**AMENDED AGENDA OF THE
PLANNING COMMITTEE MEETING**

**CITY OF BIRCHWOOD VILLAGE
WASHINGTON COUNTY, MINNESOTA
December 18th, 2025
7:00 P.M.**

STAFF REPORT

Scope: **Variances** - Principal Structure Side- and Front (ROW) Yard Setbacks; Impervious Surface >30%

Garage West Face

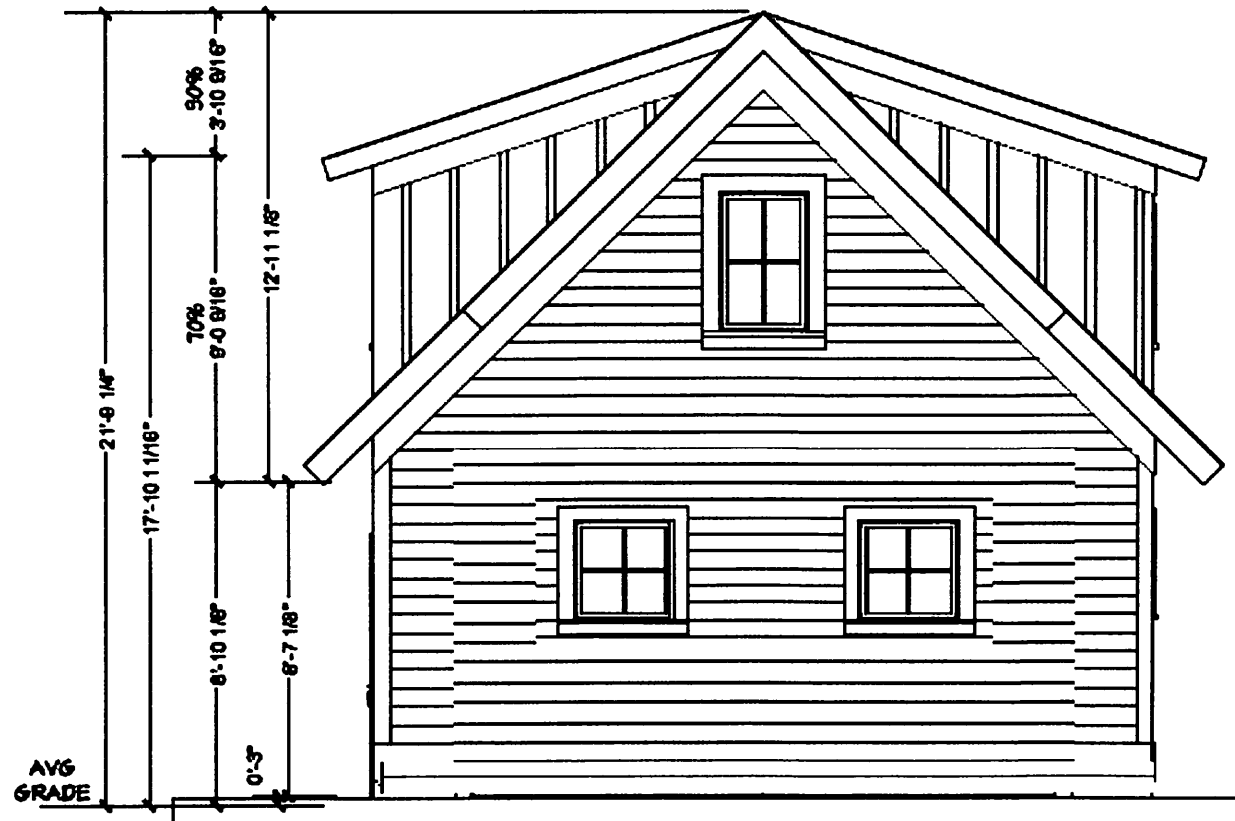
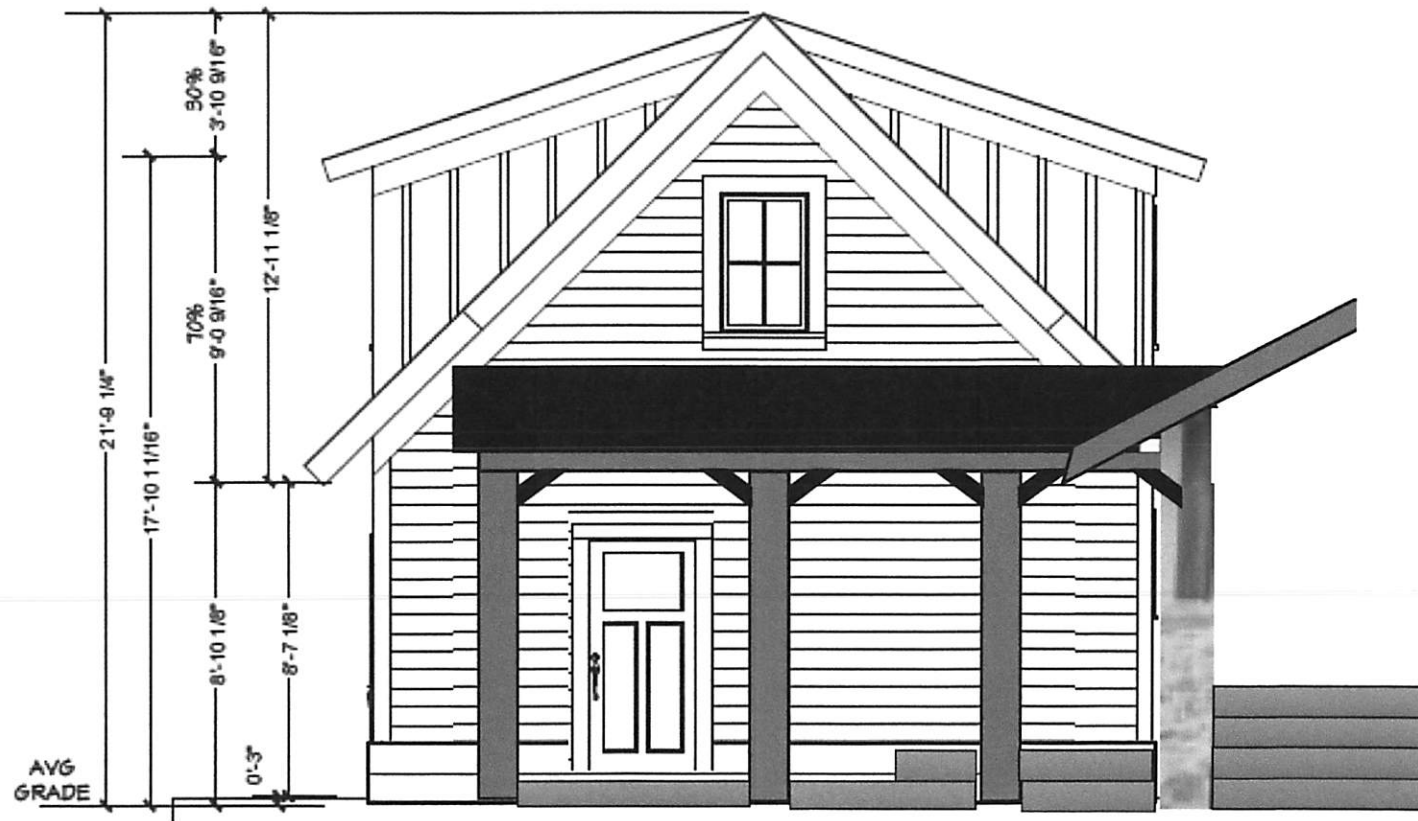
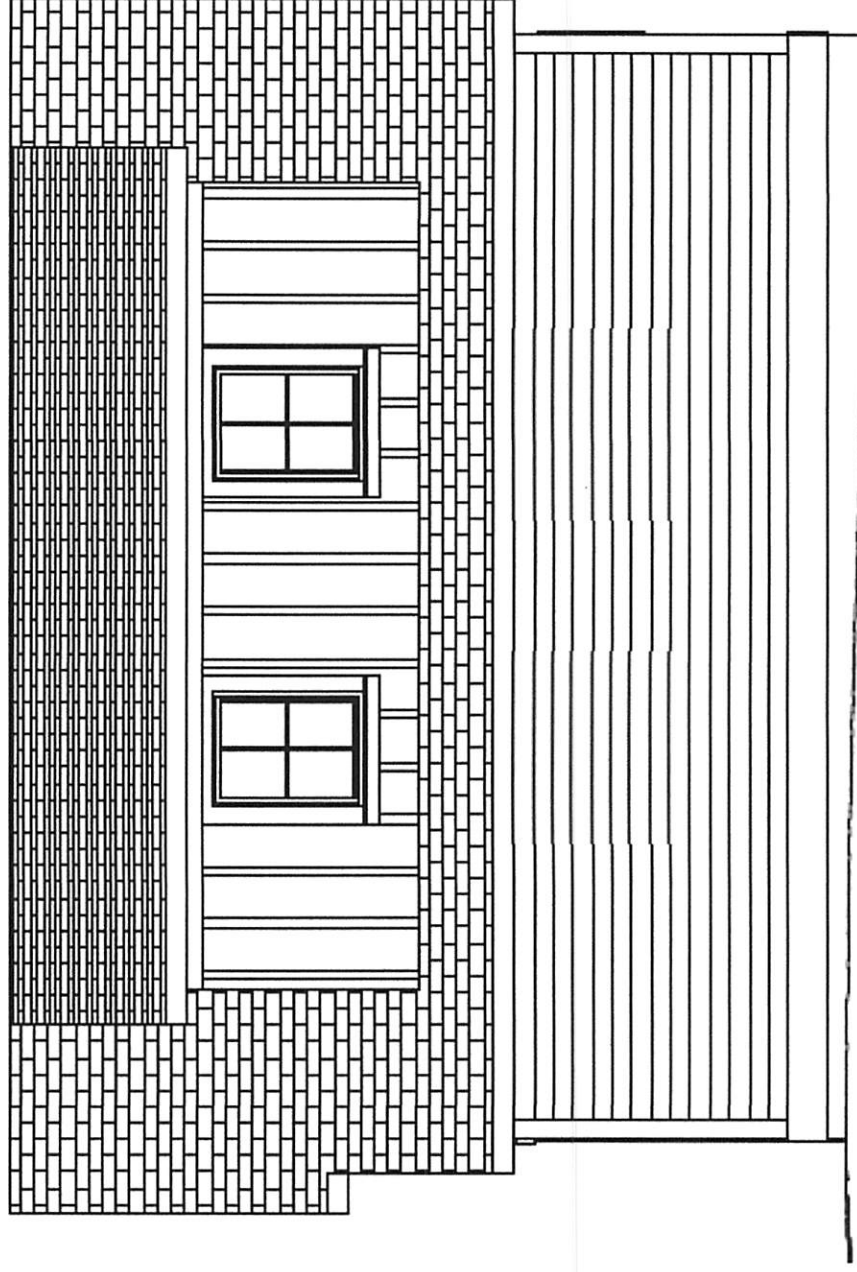
From the previous application, most of which still stands: The applicants' comments are correct, in that this is an improvement to a non-conforming situation versus a rebuild in the same location, as is allowed. While the garage footprint will take a slightly different shape, the overall size is slightly smaller, and the movement further from the property line, while not coming fully into conformance, is seen as an improvement that obviously does not increase the non-conformity. Many garages in the neighborhood meet neither the side yard nor the street side setback(s), so the character of the neighborhood is not an issue. This is a reasonable request, and the lot width and size are not a result of actions by the applicants. Should this variance be denied, the applicants would likely construct a garage in the previously existing location, which would be allowed but be a worse situation, aesthetically and practically, than what it proposed. (This last sentence has changed, in that the applicants would build a detached structure with the previously-approved setbacks, and may alter the roof pitch to gain mass and interior space.)

See staff comment on the previous variance; the same points and logic apply to this request.

The previous paragraph notwithstanding, it can be argued that the detached garage, which would limit the height of the structure to 18', does not alter the character of the neighborhood as significantly as an attached garage might, built higher in the same location. It would be reasonable to attach a condition of approval - based on that "character of the neighborhood" logic - that limits the height (using *peak* height, since the calculation of attached, gabled roof heights from the average grade yields a conforming number, or close to it) of the attached garage to a height the commission/council is comfortable with, be it the <22' proposed, or another number. Meaning, we see the reasonableness of the proposed location with reduced setbacks, *as long as* it isn't towering over the street or neighboring property at a height approaching the house height. Ordinances are often written with setbacks having a relation to the height of a structure, so there is merit in that type of condition. The applicants discuss in their narrative the reasons for the proposed placement of the garage, the improvements vs. the previous structure and to the neighborhood aesthetic, and more.

Should the Planning Commission see fit to recommend denial and the City Council deny the setback variances, be mindful that the detached structure in the same location will still be built. Further, the ordinance that determines building heights of detached garages does not distinguish between types of roof design, as it does for attached garages. The measurement is only from the average grade to the highest point of a detached garage. Put another way, the applicants could build a fully detached garage with a flat roof or very slightly pitched roof (like the proposed dormers, but without the gabled portion) 18' above the average grade, if their goal is to have storage above the parking area of the garage. If this were done, would the "mass" of the building in its location be more obtrusive than a pitched roof with dormers that reaches a peak height of 22'? Probably so.

The setback variances are a purely subjective decision, based on what the commission/council view as a "reasonable" request and as the existing character of the neighborhood. Considering the location of a detached garage is determined, allowing to be attached in the same location seems to be a reasonable decision. Potential conditions and outcomes, as outlined in the previous section, should be discussed at the Planning Commission meeting.

Front yard details

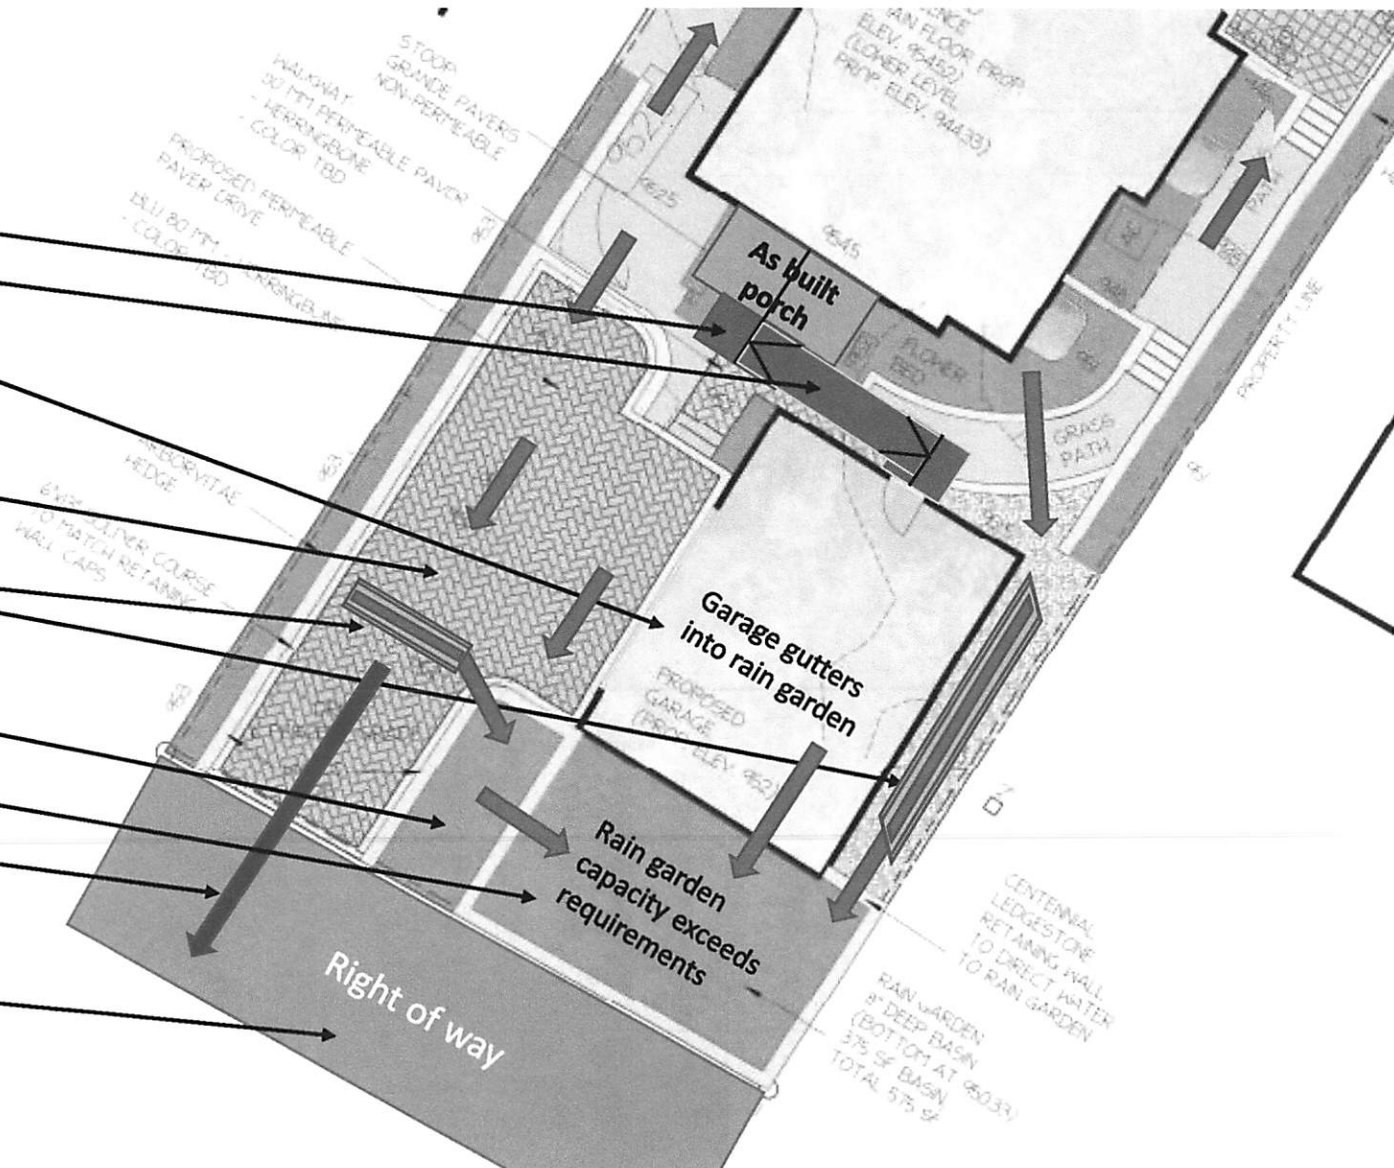
The applicants have fully complied with the necessary submittals for approval of a variance for impervious surfaces exceeding 30%. The City Engineer has provided a comment letter, which

is attached to this report. The Engineer is comfortable with the materials that have been submitted, and the calculations show compliance with the requirements of the ordinance. There are a few suggested construction improvements related to drainage and stormwater management, and a condition of approval of this variance will be compliance with the Engineer's review letter. The applicants, in their narrative, have made some valid points on the improvements to overall drainage over previously existing conditions, the reduction in unfiltered water reaching the lake, the intent and performance of the raingardens, the percentage of natural (filtering) vegetation to be planted which will greatly exceed the minimum requirements of the ordinance, etc.

The owners of 131 Wildwood asked to modify the plans to add the breezeway. It was requested to add the breezeway or partially add the breezeway to hit the 30% impervious surface threshold exactly and avoid the variance. After Bolton and Menk's review, it was our opinion that the owners should apply for an impervious surface variance even though the numbers might show on the plan to be at 30%. Engineering reviewed the impervious surface calculations and did not see any missing information at this time and did not find errors in the calculations.

With the relocation of the infiltration basin, engineering requested an infiltration test (to be done in the spring) to verify infiltration is still an option with construction potentially driving over the new location of the basin. Typically, these areas should be fenced off to avoid compaction during construction. If the infiltration test shows that infiltration is not an option, a filtration system design will be requested of the homeowner at that time. That change should not cause a significant enough change to need to come back to the planning commission. It should consist of adding a drain tile running from the ponding area along the length of the property and discharging toward the lake. The calculations of the infiltration pond meet the city's requirements, and Bolton and Menk does not see this change as being of any concern.

The impervious surface variance is reasonable, if an applicant can prove that they can meet stormwater control requirements within the ordinance and provide the necessary mitigation measures for drainage and filtering. In this case, they have, and the City Engineer has recommended approval of the variance.
